TO: Expert Panel considering Taharoa
Ironsands Limited's substantive Fast-track
application for the Central and Southern Blocks
Mining Project

WWLA0546

Taharoa Ironsands Limited Fast-track Application – Response to Comments from Invited Parties Relating to Hydrology

Figure 1. Comparison of measured lake levels and daily abstraction rates 2019-2021.

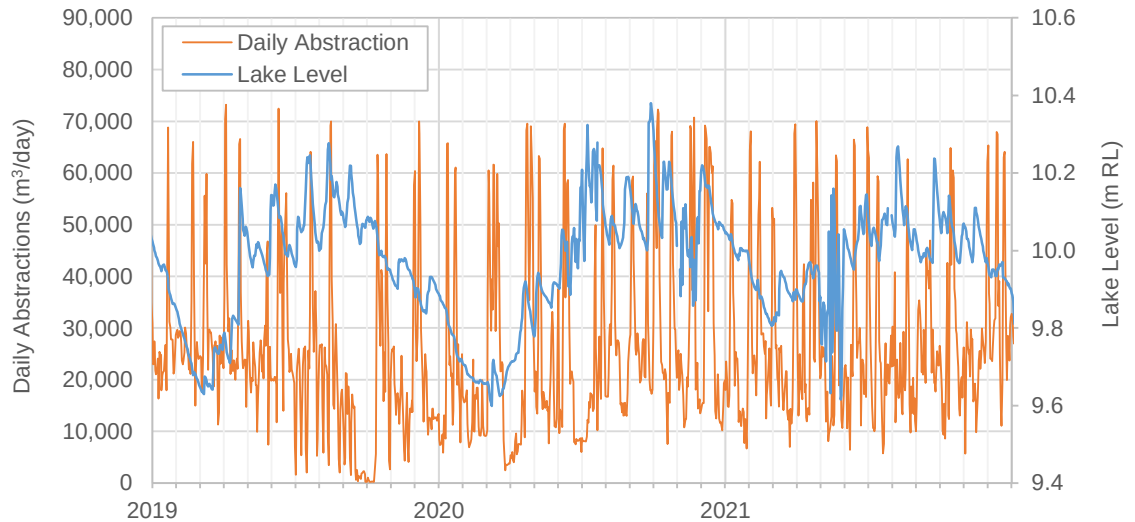
Comment: DoC and Earthtech note the maximum consented daily abstraction of 75,000 m³/day was not modelled and that the use of average abstraction rates in the scenarios does not simulate peak demand conditions. As such they conclude actual drawdown rates could be higher than assessed.

Response: The maximum consented abstraction rate of 75,000 m³/day was simulated as part of the basecase /calibration scenario (Section 4.4 of the Lake Hydrology Assessment). Review of the simulated lake levels from this scenario (and actual historical measured lake level data) indicates occasional abstractions at the maximum rate (or close to it) do not result in substantial lake drawdown. The larger, longer duration drawdown events (which presumably are the ones of potential concern) occur as a result of the combined effects of lower catchment inflows during summer and the cumulative abstraction volume through the summer period.

Figure 1 presents a comparison of daily abstraction rates and measured lake levels, focusing on the period 2019 to 2021 (inclusive). This shows that lake levels do not drop for extended periods of time during periods of episodic high abstractions (i.e. >60,000 m³/day). For example, between the period of summer from 1 November 2019 and 1 April 2020 there were nine days where abstractions exceeded 60,000 m³/day. However, lake levels only dropped by 400 mm to ~9.6 m RL. However, during the period 1 November 2020 to 1 April 2021, there were 17 days where abstractions exceeded 60,000 m³/day, but lake levels only dropped by 200 mm to ~9.8 m RL.

The fact that the summer 2021 period had a higher minimum lake level than the preceding summer, despite having a greater number of days of abstractions exceeding 60,000 m³/day, demonstrates lake levels are a balance between catchment inflows and cumulative summer abstractions, rather than periodic larger abstractions.
